# City of Alexandria, Virginia

## MEMORANDUM

**SUBJECT:** REVISED PLANS FOR 628 N. WASHINGTON ST, BAR CASE #2015-0064

Docket Item # 2  
BAR CASE # 2015-00064

Figure 1: Previously proposed front facade (April 15, 2015)

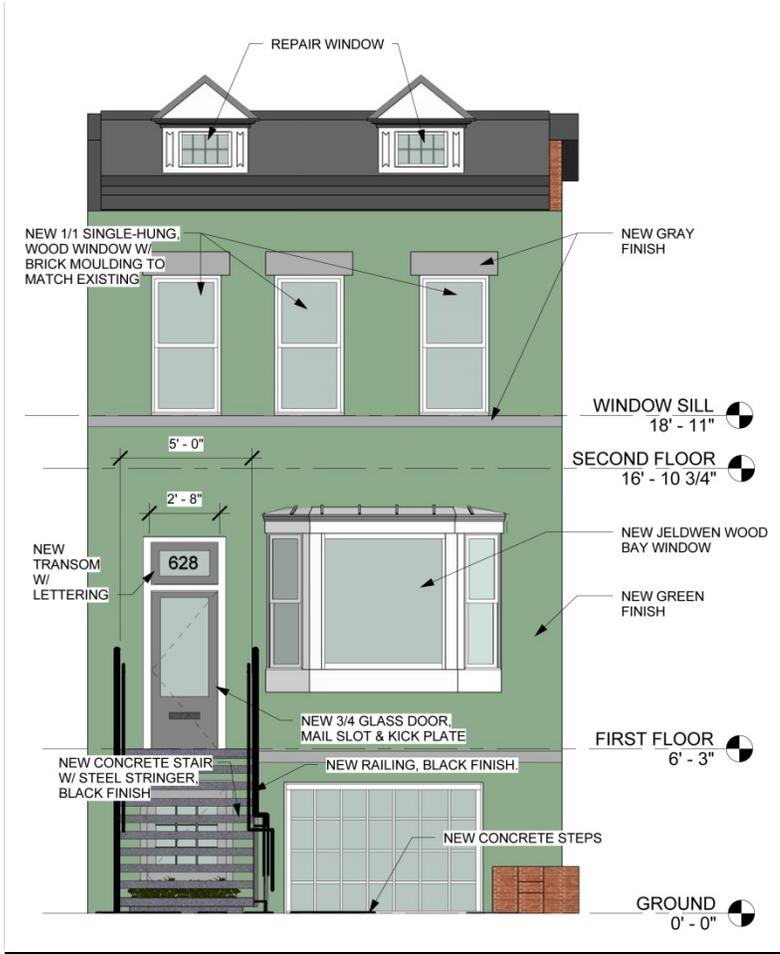
Ms. Roberts said that she opposed the design of the applicant's proposed steps and asked that they consider wood, steel or brick steps which would be more compatible with the immediate context.

Ms. Miller said that she didn't think the multi-pane window at the basement level was appropriate, especially with the proposed window changes on the upper floors.

Mr. Neale said that he liked that the upper windows were being returned to the historically appropriate 1-over-1 configuration and thought that it would be appropriate to change the basement window to a tripartite configuration to match the bay window mullions above. He said that the new stair was not compatible and suggested that the applicant consider integrating brick into the new stair, perhaps as tread pavers in a metal pan. He said that he supported leaving the building painted because the other buildings in the row are painted.

Mr. von Senden said that there seemed to be four items for discussion: 1. The original 1-over-1 windows were there for 55 years and the porch was there for just as long; 2. He said that he didn't support leaving the basement window in its current configuration; 3. He said that the stair

was too utilitarian and that it needed to be more ornamental. 4. He said that the other townhouses in this row were painted, so it was appropriate to keep this townhouse painted.

Mr. Carlin said that he agreed with both the NPS and HAF, and thought that the basement window should be replaced with a more appropriate window. He said that the stairs have been brick for 50 years and that if the applicant wanted to install metal stairs they should be more delicate and decorative.

Chairman Fitzgerald said that he would be supportive of metal stairs but believed that they shouldn't project more than they presently do, because a greater projection creates more of a perceived mass. He said that he thought the basement window was jarring.

The Board felt that the front stair and railing should be restudied to be more compatible with the building and the importance of the GW Parkway, while still fitting within the context of the block of similarly altered rowhouses. The Board also requested that the applicant consider replacing the multi-pane window at the basement level with a new window that has mullions similar in proportion to the proposed bay window above and supported one-over-one sash windows on the first and second floors.

On April 15, 2015, the Old and Historic Alexandria District Board of Architectural Review (BAR) unanimously deferred the case so that the applicant could restudy the proposed replacement stair, railing, and bay window replacement. The Board found the previously proposed stair too utilitarian in design and stated that this stair would set a poor precedent for future alterations to this row of historically identical townhomes. The Board also found that the multi-pane basement window should be replaced to be consistent with the one-over-one windows proposed for the rest of the building.

Figure 2: Proposed front facade (June 17, 2015)

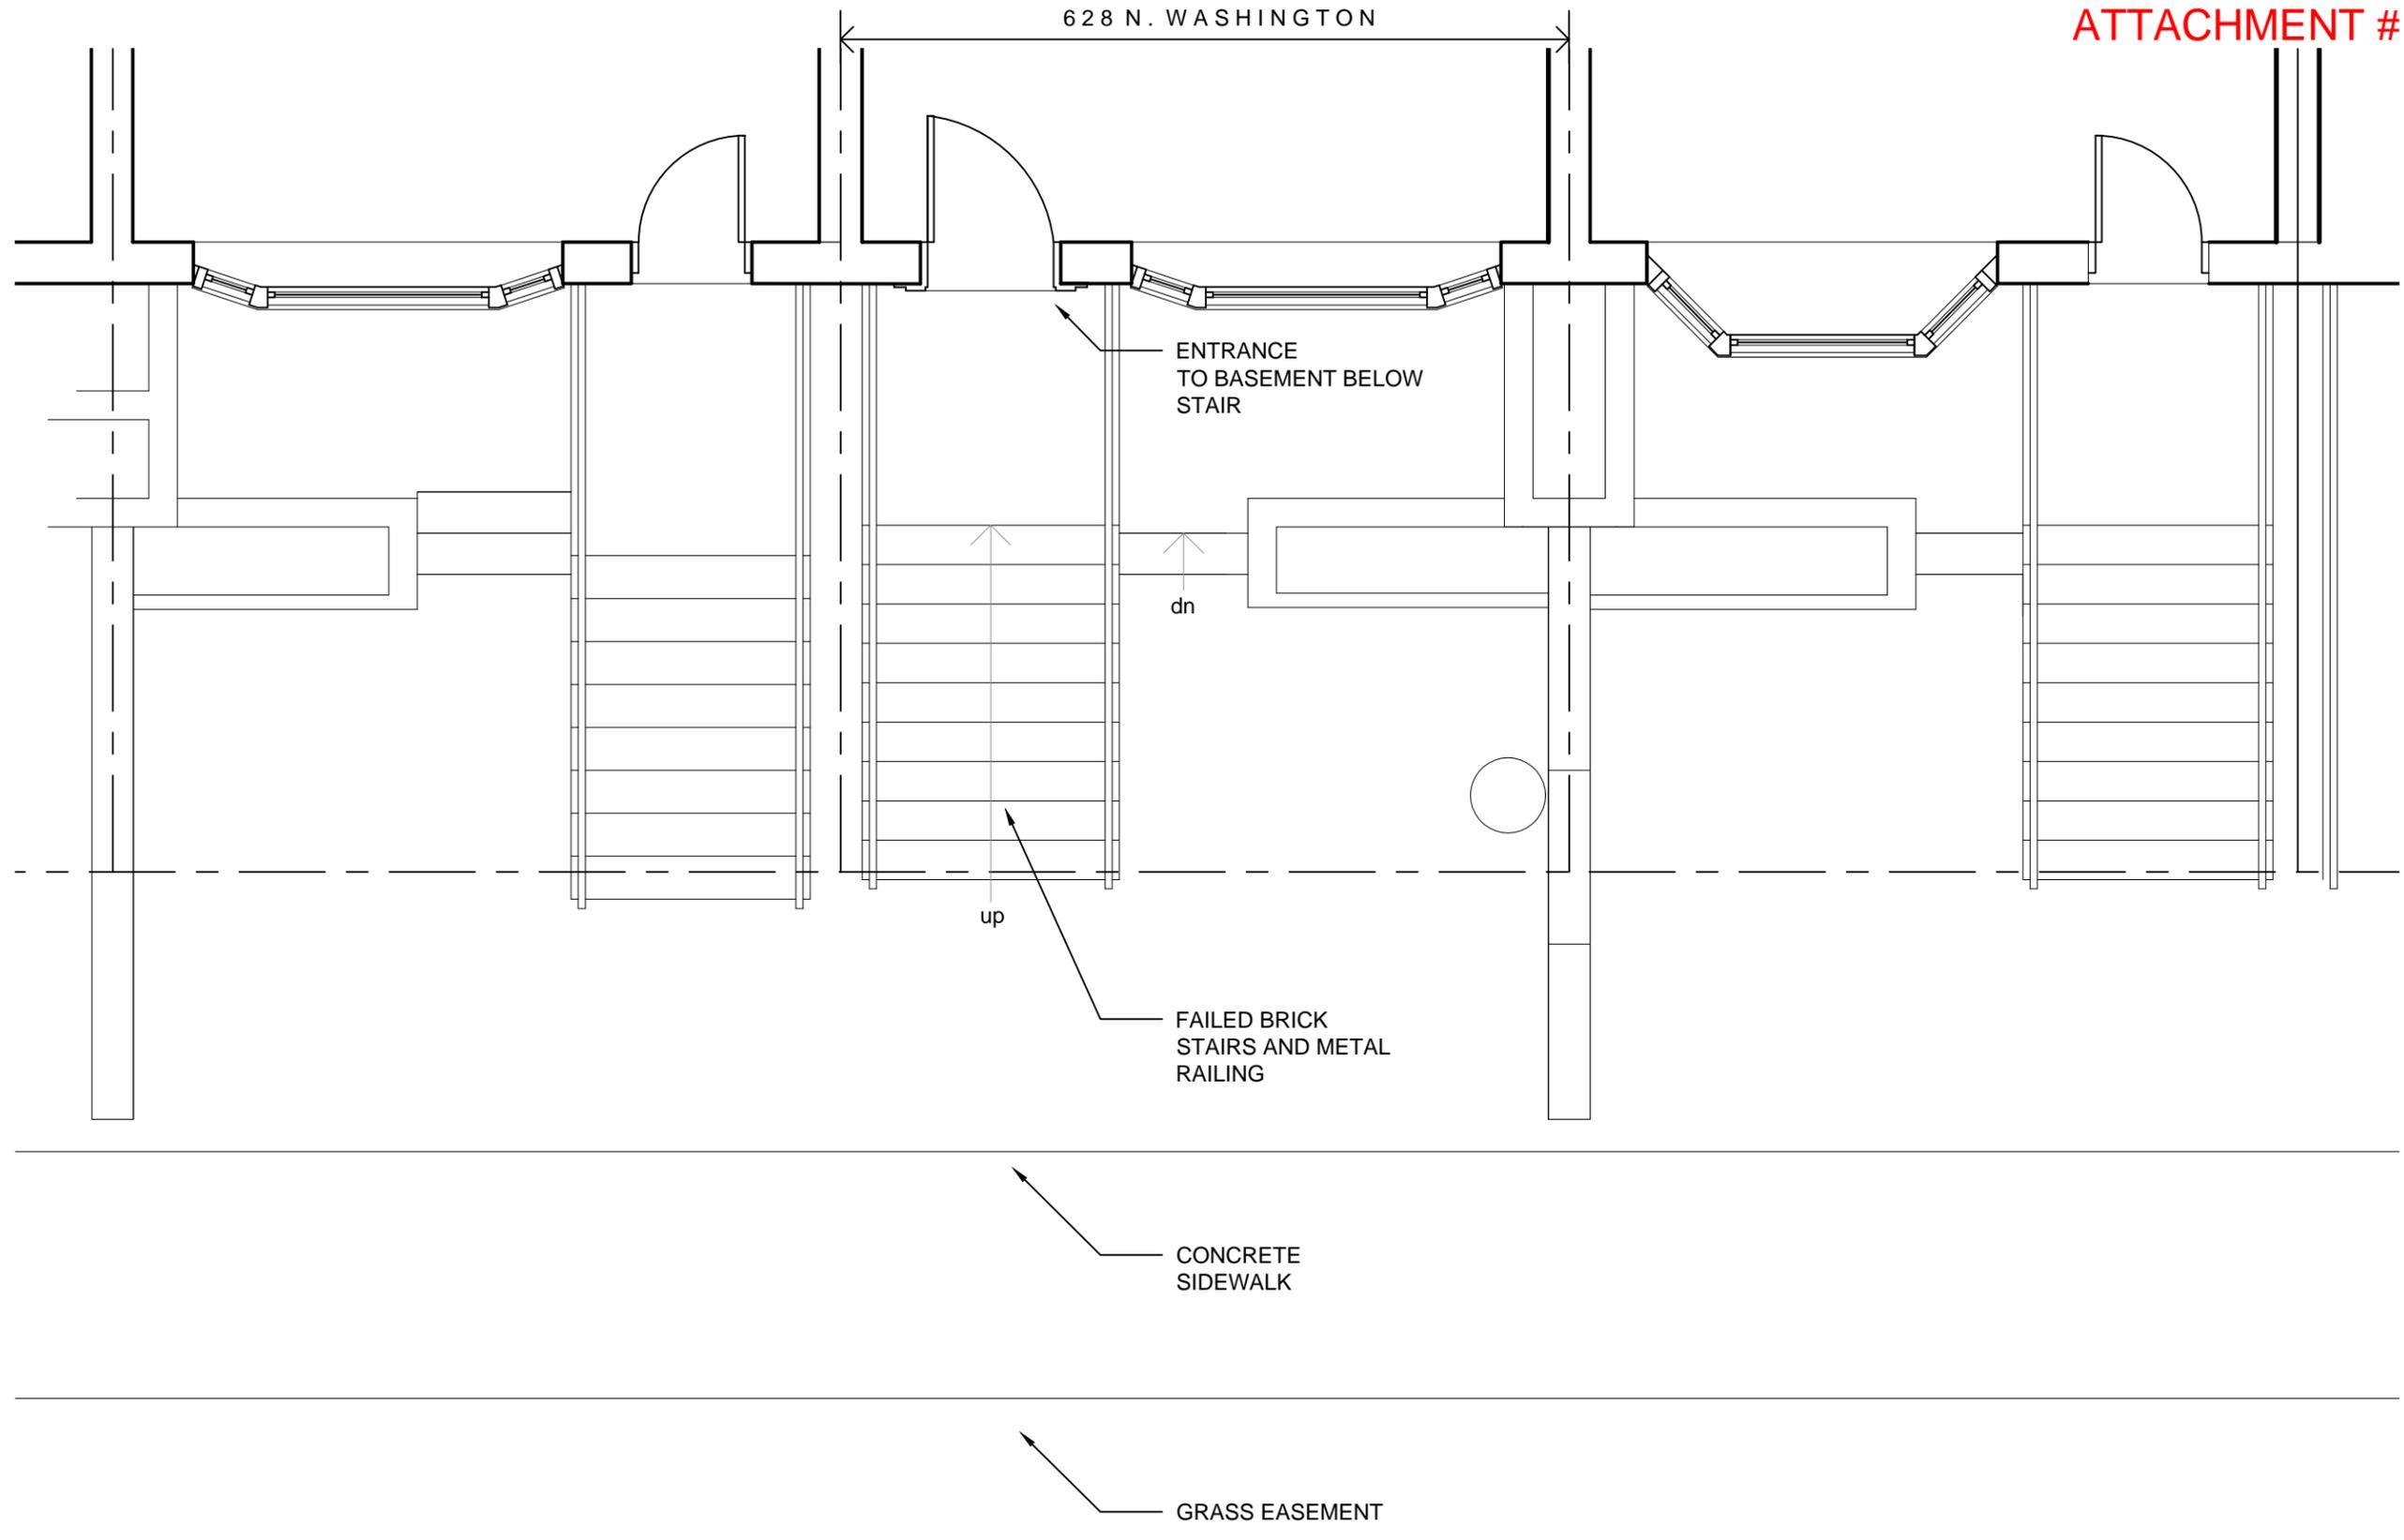
The applicant has restudied the proposal and addressed the Board’s comments from the April 15<sup>th</sup> hearing. The applicant now proposes to replace the basement window with a fixed, single pane window flanked by two double-hung one-over-one windows to mirror the proposed bay window above. The bay window detailing is improved, with new wood brackets to be placed beneath.

The applicant now proposes a metal stair, as opposed to the previously requested concrete filled metal pan stair. The applicant has provided two styles of balusters, option 1 and 2, and staff finds both styles to be compatible to the building and neighborhood context. Overall the stair is consistent with the Design Guidelines; a metal stoop is appropriate to the age of the structure, and will better relate to the nearby context where both brick and metal stairs exist. Furthermore, this stair is a contemporary interpretation of a Victorian stair that adequately differentiates contemporary alterations from the historic materials. The Design Guidelines do not mandate replicative design or style, but compatibility.

Staff recommends approval of either railing, at the applicant's option, and the other proposed alterations to the east elevation, as submitted. Staff recommends that the applicant work with staff to correct the existing violation on the west elevation (vinyl lattice and inappropriate railing) as well as to repair or replace windows and doors, consistent with the BAR administrative approval policies.

Figure 1: Image of the residential development at 614 – 632 N Washington Street as shown in the *Alexandria Gazette* from April 13, 1912 (source: Special Collections).

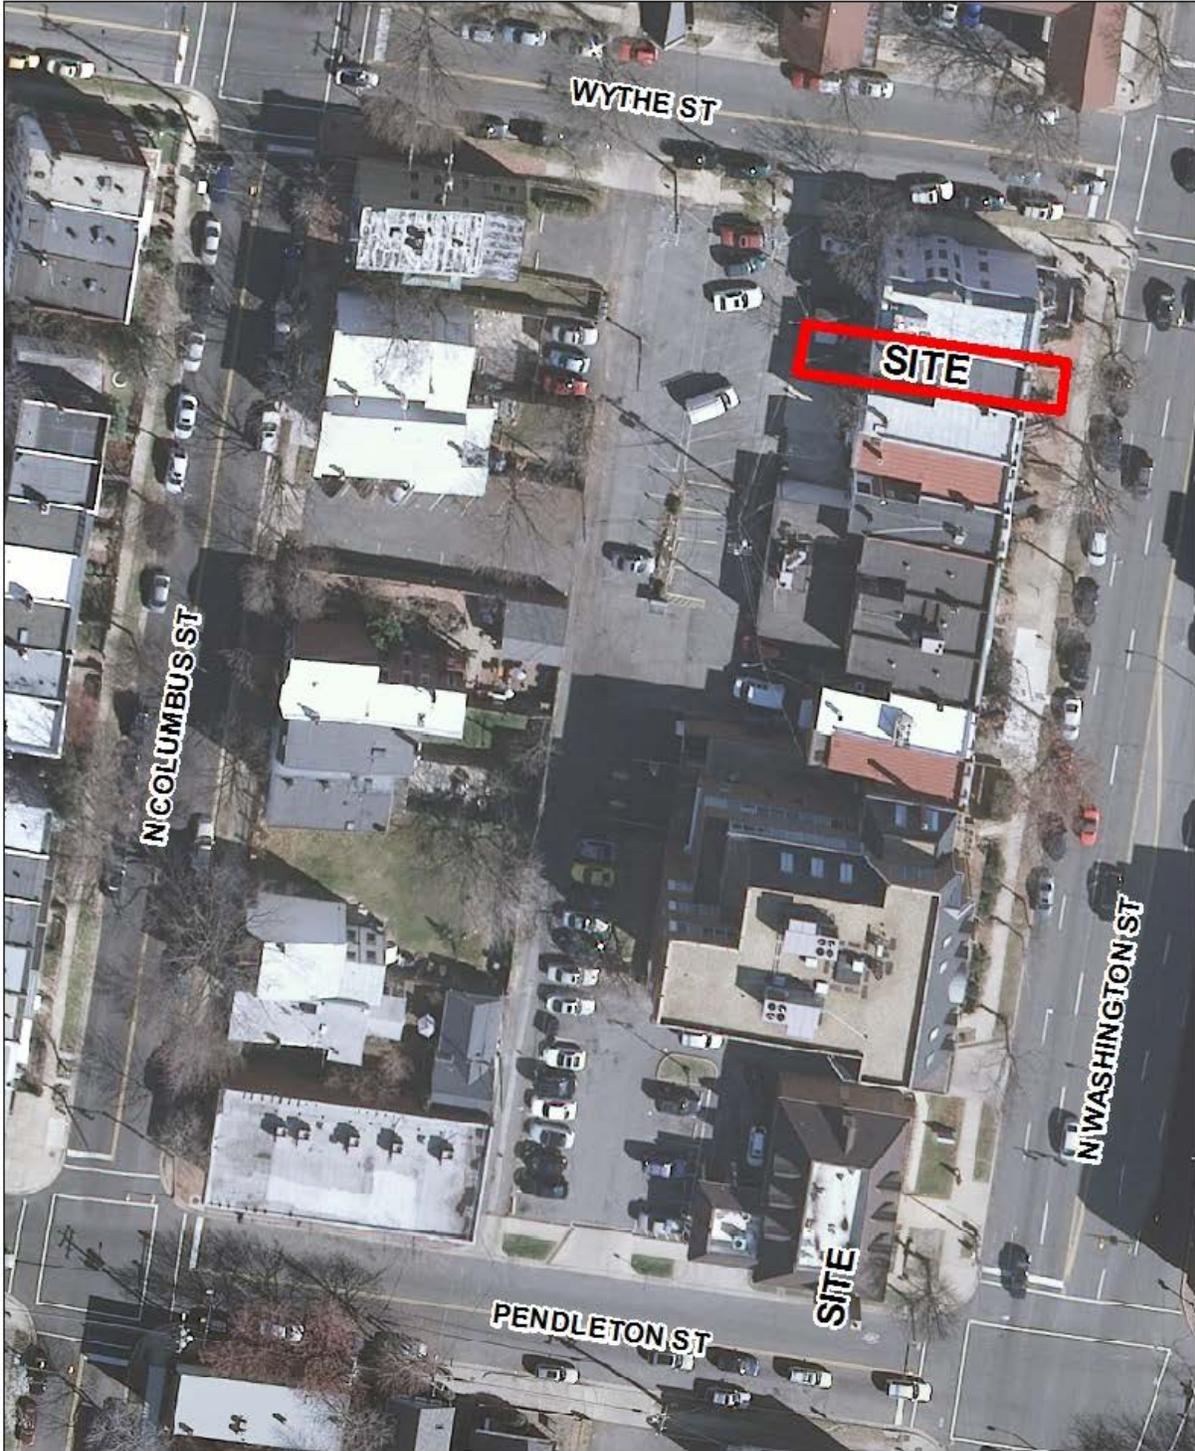
Staff laments the loss of the original front porches in this townhouse row. These were primary character defining features, as is evident from the 1912 photo and those similar rows with extant porches in the 500 block of North Washington or the 1400 through 1600 blocks of King Street. Unfortunately, given the present use of the building and the desire for additional light for the basement tenant, reconstruction of this porch is not an option at this time.

Staff supports the applicant's proposal to replace the existing multi-light window sash with single light sash, as shown in the 1912 photo. Staff recommends that the Board condition any approval with the requirement that all window replacements be consistent with the [BAR Window Policy](#). Staff believes the existing window *frames* on the front and rear elevation are original and that there may be original sashes on the rear. The [BAR Window Policy](#) calls for preservation of these original features, if staff determines in the field that they are not beyond reasonable repair. Relatively inexpensive sash kits are available from several manufacturers that retain the existing frames and replace only the operable parts of the window with modern glass and weatherstripping.

**Figure 2:** Existing plastic lattice on north elevation of porch. Staff has not located record of any BAR approvals for porch alterations at this address.

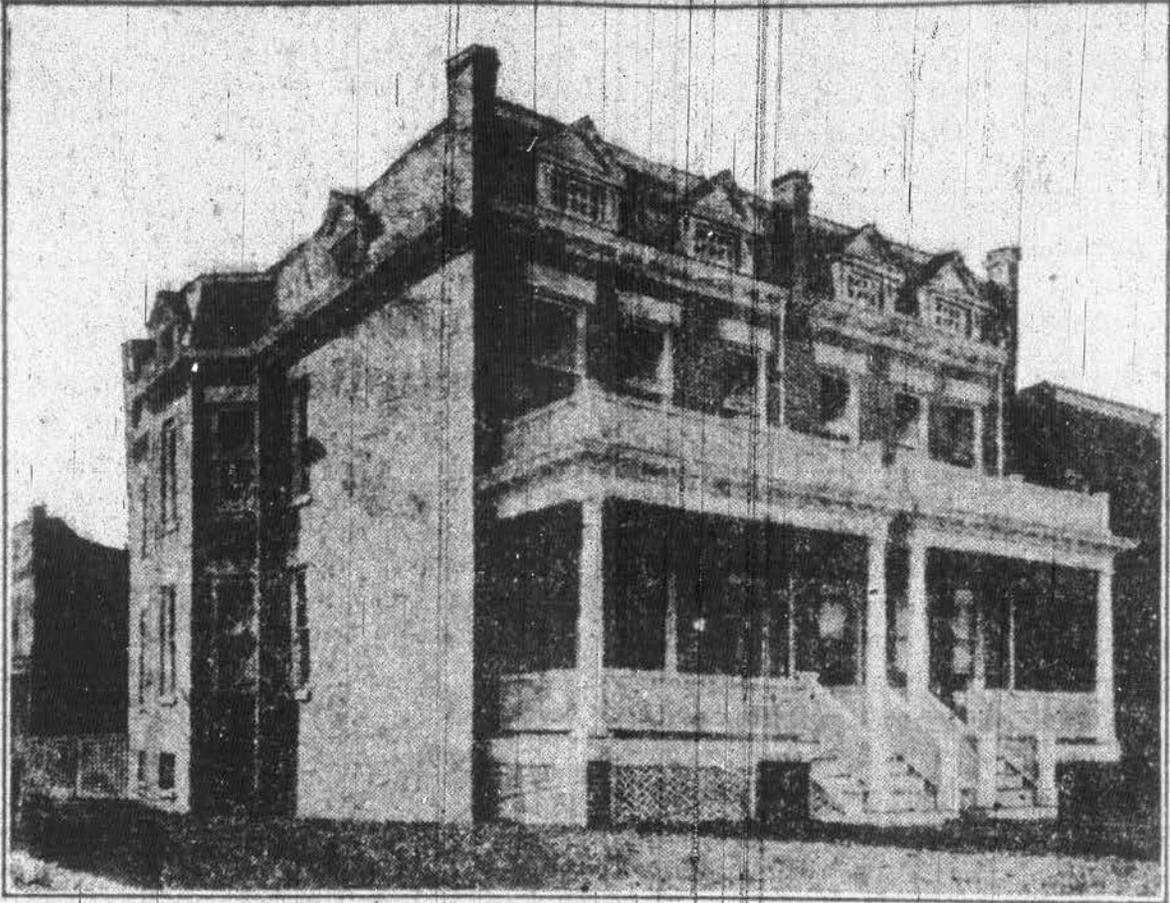
The alley located behind the building is a public alley; therefore all exterior changes visible from this location require review by the Board. Staff is gratified that the applicant has chosen to preserve and rehabilitate the rear porch and windows, but recommends that the existing plastic lattice on the north elevation of the porch be removed as part of the renovation (see Figure 2, below). While lattice is appropriate for this age building (and actually part of the original construction – see historic image above), lattice of this quality and location is completely inappropriate and does not meet any of the BAR policies or *Design Guidelines*.

Furthermore, staff was unable to locate any previous BAR approvals for the existing porch railing, which appears to be a wood railing one would find in a suburban development's deck, not early 20<sup>th</sup> century rowhomes. Staff recommends that the Board condition any approvals for the rear porch to include a revised porch rail and columns, with final approval by staff. Staff has provided an example of stylistically appropriate porch details below.

1. The rear elevation porch rail and column design be in keeping with the Colonial Revival style of the building, with final approval by staff;
2. The plastic lattice on the north elevation of the rear porch be removed;
3. The proposed lattice on front porch must be wood;
4. The applicant coordinate with staff prior to applying for a building permit to assess the existing windows and replace or repair in accordance with the *BAR Window Policy*;
